UNITED STATES PATENT AND TRADEMARK OFFICE

Office Action Summary

10/780,587

WATANABE ET AL.

Fig. 4.

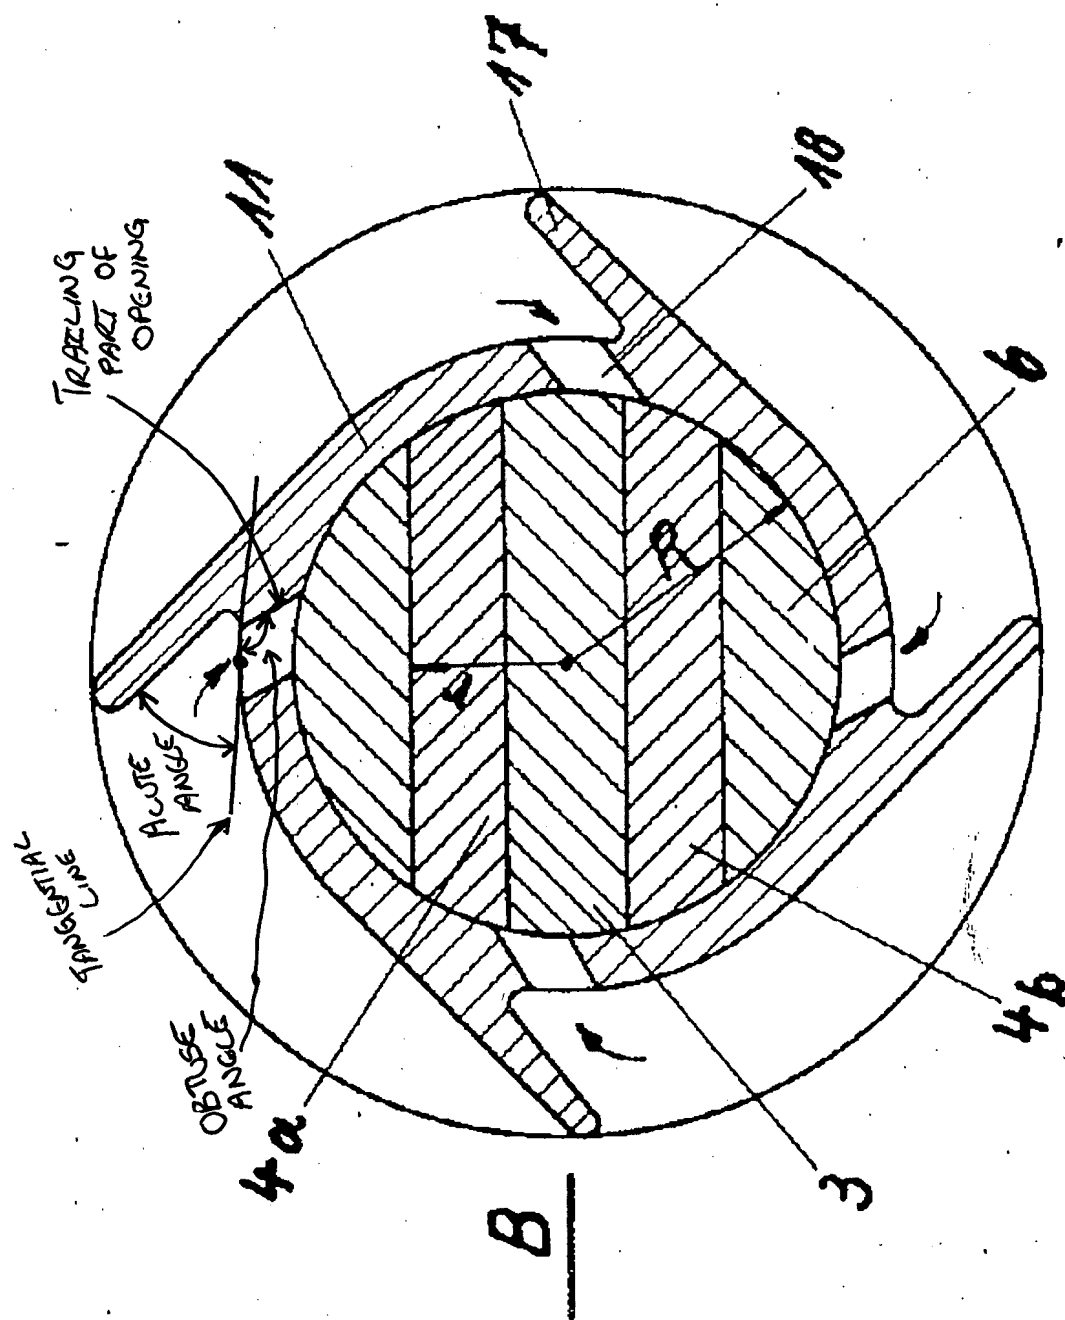
pinion shafts (the vanes 17 extend out from the recess holding shaft 1' and extend from the recess for shaft 12 to that for shaft 1), the first projection portions (17) having an inclined surface (the vanes 17 are sloped), the inclined surface defining an acute angle relative to a tangential line of the outer surface at a center point of the projected portion (see Figures 1 and 2 where the vanes are shown as acute angles or see the Figure at the end of this action)
